<h1 style="text-align: center;">CONCESSION</h1>				Reference	TN-006534846
					Suffix	
	Drawing N°	V53971224			Revision	
	Part N°	V53971224030	Quantity	1	Page	1 of 2
	Part Description	A-BRKT INSTL RIV UD C20-C26 RH			A/C Type	A350-1000

Item SN	N/A	CA code and s/n	WG500/TN10769		MSN	00786
Description of Divergence Location:FUSELAGE SECTION 13/14,ON UPPER PART,STRUCTURE,RIGHT SIDE,EXTERNAL SURFACE NOT AFFECTED Frame 022A,Stringer 25 NonConformity 0001 : Type of nonconformity: Oversized Hole Characteristics Nominal hole specification : ABS1707BP1V3A Nominal Fastener Sys-fastener : EN6115B3E + ABS1738K3 Drilled Hole Specification : ABS1707CP1V3A Nominal Pitch & Edge Distance : Yes (see Sketches) NON CONFORMITY: OVERSIZE FASTENER INSTALLED. SEE MORE DETAILS IN SKETCHES. AFFECTED PARTS:				Responsible Design Office Decision Acceptable as is ASR limits not exceeded NON CONFORMITY: OVERSIZE FASTENER INSTALLED. - Acceptable as is		Attached documents 2 pages
Allocation by system data transfer - 13/05/2025				Limitations imposed on the part No limitation		
Function	Originator	Design office Design Stress or Specialist		Quality		
Name	KUMAR HARSHIT	SATHYANARAYANA KUMAR	SPIEKER TIMO		PETERS SEB

1

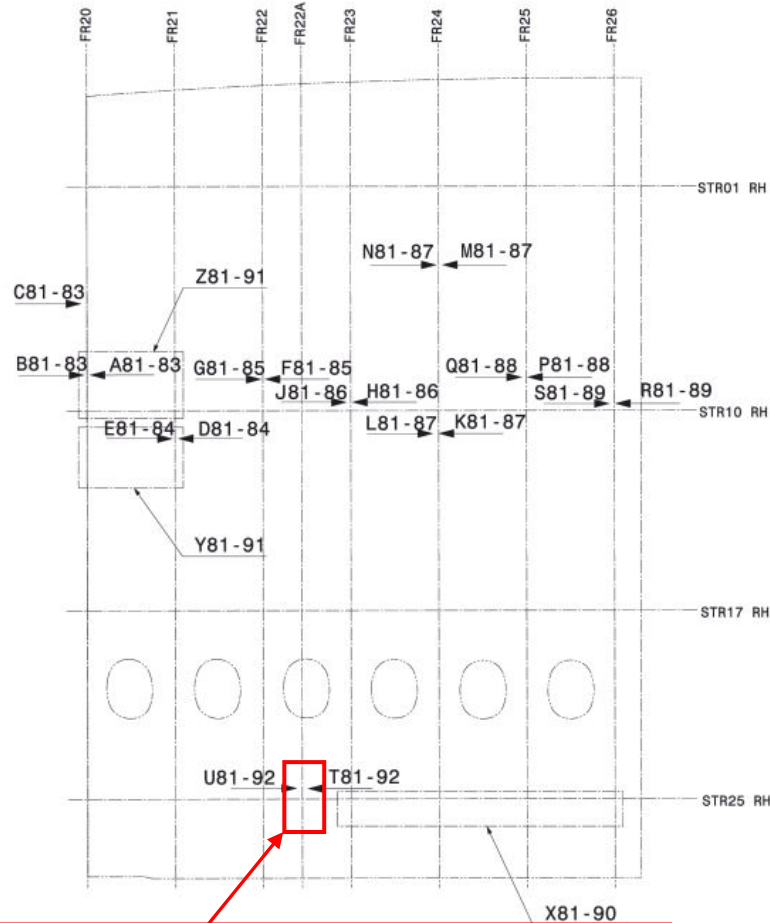
AFFECTED AREA – FRAME 22A, STRINGER 25RH

NON CONFORMITY: OVERSIZE FASTENER INSTALLED.

SEE MORE DETAILS IN SKETCHES.

SURFACE PROTECTION WILL BE COMPLETED DURING MANUFACTURING ACCORDING TO DESIGN SOLUTION.

2

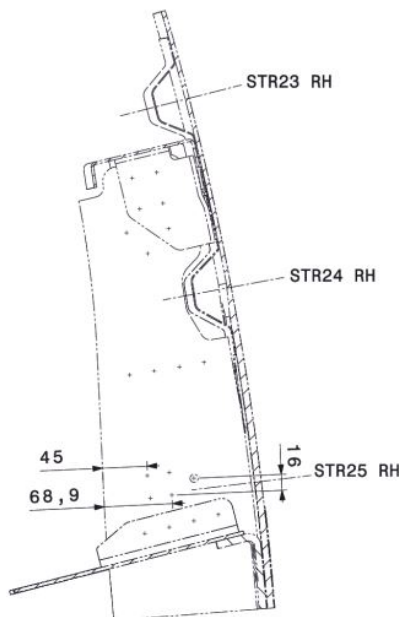
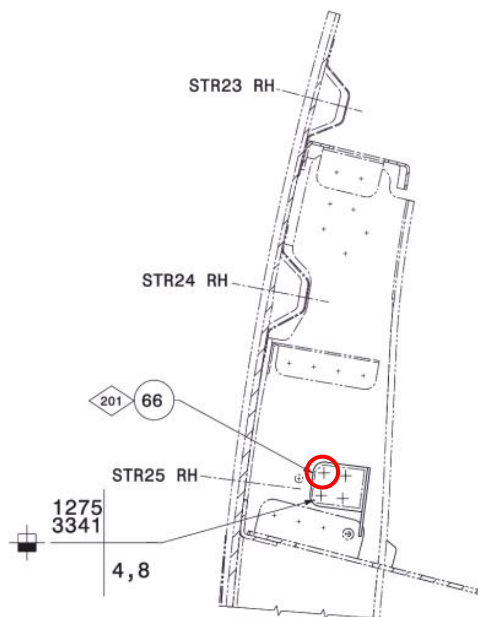
NON CONFORMITY: 1x OVERSIZE FASTENER INSTALLED.

NOMINAL:
HOLE CODE: ABS1707BP1V3A
FASTENERS: EN6115B3E + ABS1738K3

ACTUAL:
HOLE CODE: ABS1707CP1V3A
FASTENERS: EN6115B3AE + ABS1738K3A

HOLE POSITION, EDGE AND PITCH DISTANCE AS PER DRAWING.

AFFECTED PARTS:
V5327431320400 DOOR FRAME C22A
V5397054320400 BRACKET
